From: Larson, Karl W., P.E. (VDOT)
Sent: Friday, May 31, 2024 10:34 AM
To: Zickler, Andrew M., P.E. (VDOT)
Subject: FW: 45893 (116663) - Opitz Blvd: RFI 185 - CPSR Railing
Attachments: [#185 - B688 CPSR RAILING-202405231417.pdf](#); [CPSR Railing_Roadway.JPG](#); [CPSR.jpg](#); [CPSR Railing_Sidewalk.JPG](#)

Subject: 45893 (116663) - Opitz Blvd: RFI 185 - CPSR Railing

We are requesting VDOT concurrence on RFI #185 to accept as-is. The RFI is attached herein.

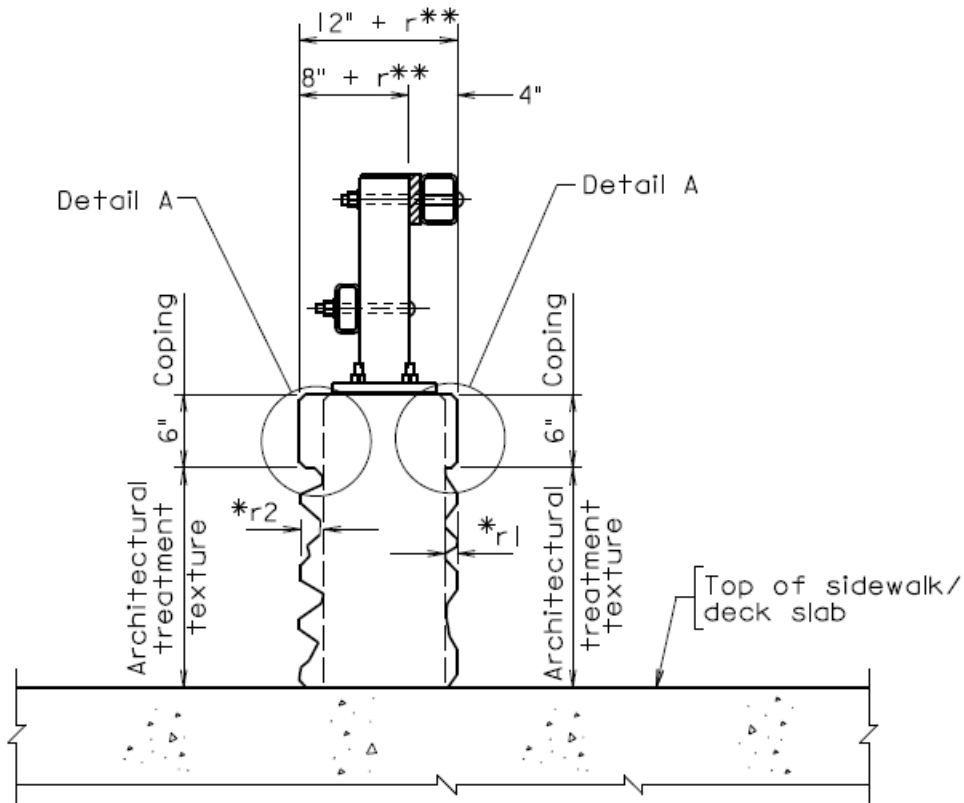
The contract plans and VDOT standards are clear that the steel rail is to be flush with the concrete face on the traffic side.

Please disregard the highlighted statement below as it is not correct when using an architectural finish.

We did have some fit-up challenges with the anchor bolts being within the rebar cage. This may be a contributing factor.

The traffic side was built with a 1" offset.

What is an appropriate traffic side construction tolerance (concrete and steel rail offset) that will not adversely affect collision rollover performance?

Per the attached photos, you will find the CPSR coping was installed 14" in width. **Per plan the railing on both the roadway and sidewalk side are to be flush with the coping.** As installed the railing on the sidewalk side is flush with the coping and the railing on the roadway side is 1" shy (recessed into) of the coping.
